SERVICE BULLETIN #LO-007

RE: Mini Max Refrigerator Baffle

MODELS: Little Guy Mini Max.

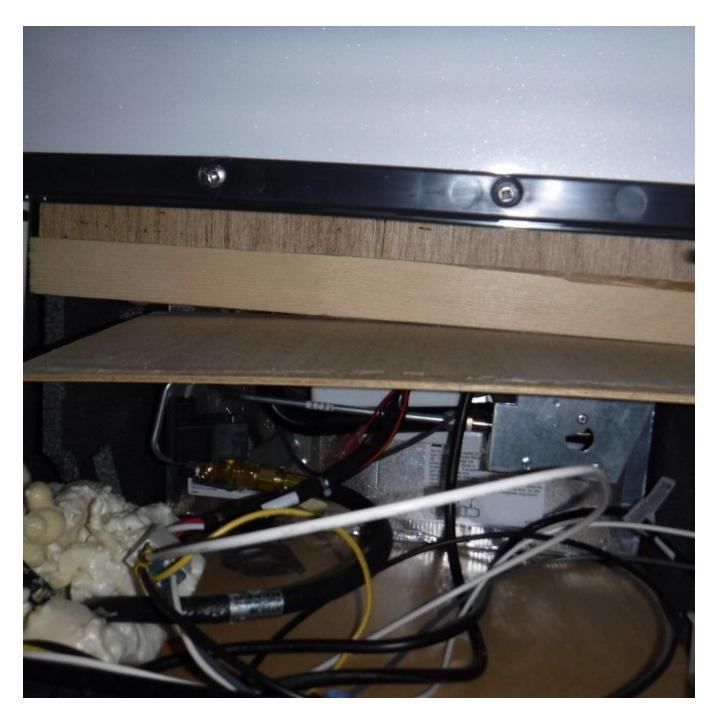
PROBLEM: It is possible for the fasteners to fail and the baffle will fall behind the fridge. This is dangerous due to the wood baffle potentially falling close to the fridges boiler tube which can get hot when the fridge is operating.

Baffle has broken and fallen down to the bottom of the fridge cabinet

CORRECTION: The baffle can be secured again to the fridge cabinet
